First Release

MODIFICATION OF THE SMALL A/C COMPRESSOR HARNESS – VOLTA COMPRESSOR

Prevost vehicles

FIGURE 1: ORIGINAL HARNESS

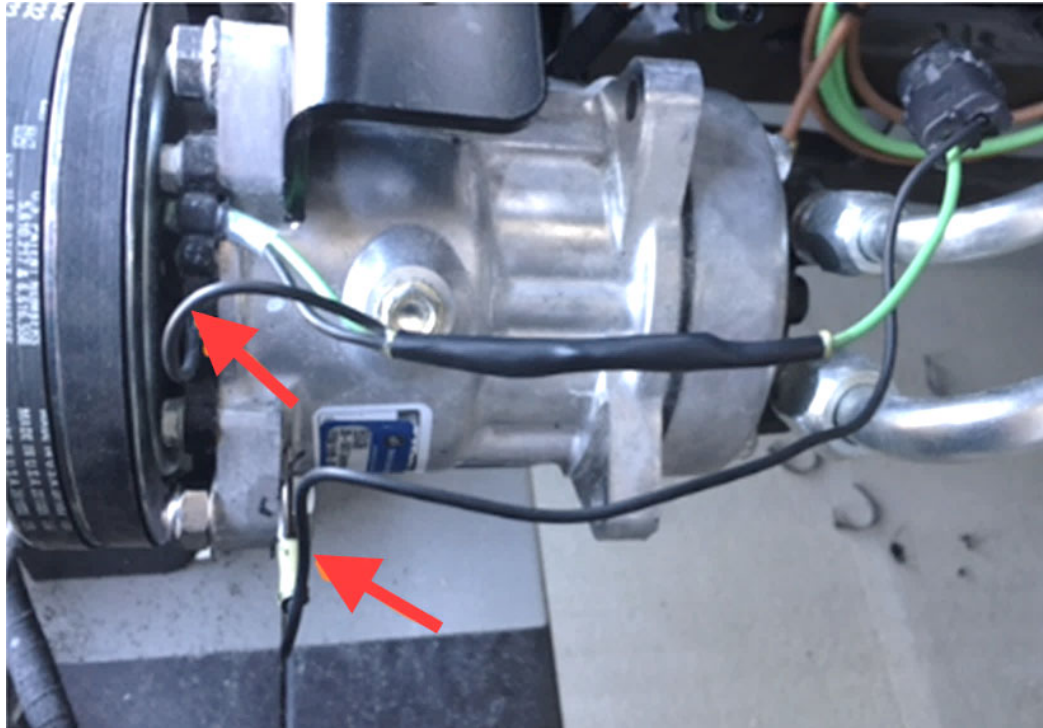
1. Modify the harness as described in the following steps.
 - You will discard the diode. The clutch coil black wire will be routed directly to the connector while eliminating the two ground terminal connections identified with red arrows (figure 1).
 - You will need a PED connector extraction tool (figure 2).
